DESIGN CP	DRAWN BY CP	DART AEROSPACE LTD HAWKESBURY, ONTARIO, CANADA	
CHECKED #	APPROVED #	DRAWING NO. DSI 9065	REV. C SHEET 1 OF 1
DATE 01.04.11		TITLE AS350/355 STEP INSTALLATION	SCALE NTS
A	97.05.20	NEW ISSUE	
B	98.11.23	NON-SPECIFIC BOLT ADDED	
C	01.04.11	REMOVED SPACERS

## DART SERVICE INSTRUCTION

TO AMEND INSTALLATION DRAWING D350-591 REV D  
REF. CANADIAN STA: SH92-6  
REF. FAA STC: SH967NE

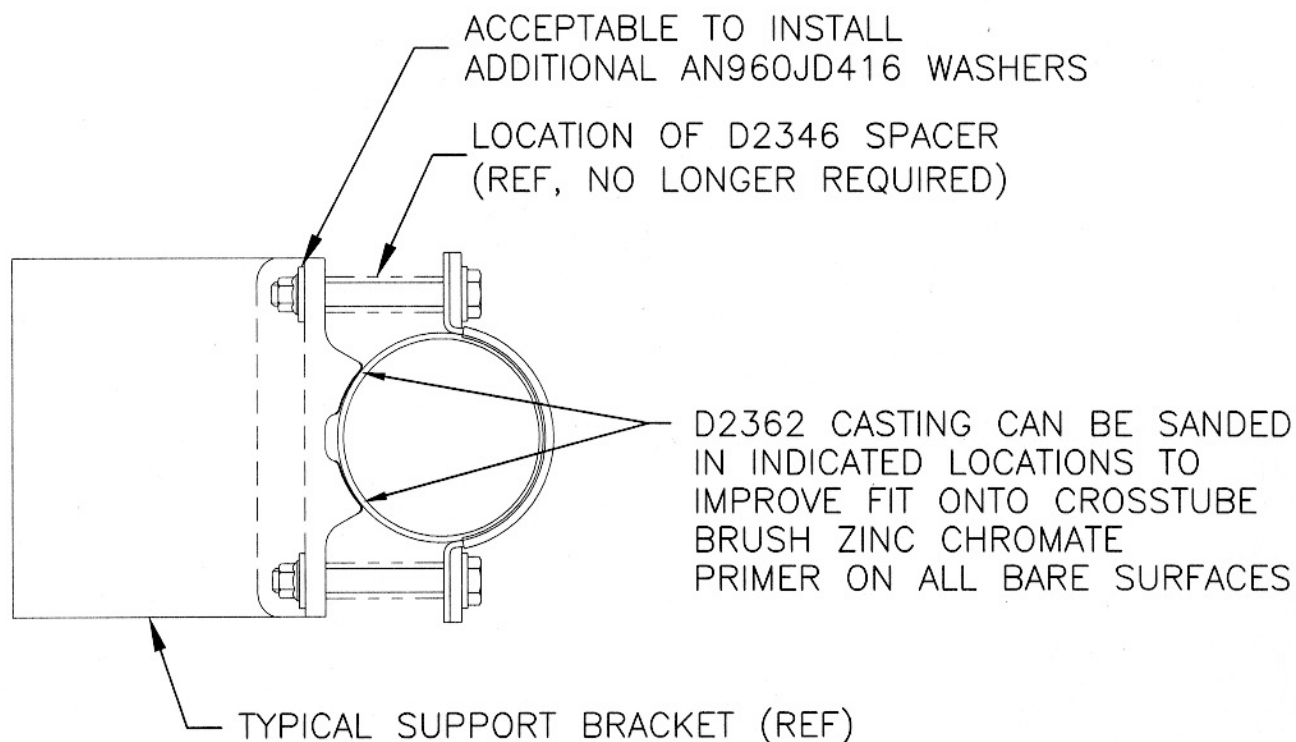
FOR THE D350-591-111/-111A/-113/-115/-117/-119  
INSTALLATIONS, THE D2346 SPACERS ARE NO LONGER REQUIRED.  
LONGER OR SHORTER AN4 BOLTS MAY BE SUBSTITUTED OR  
ADDITIONAL AN960JD416 WASHERS CAN BE INSTALLED UNDER THE NUT  
TO ENSURE 1.5-4 THREADS IN SAFETY.
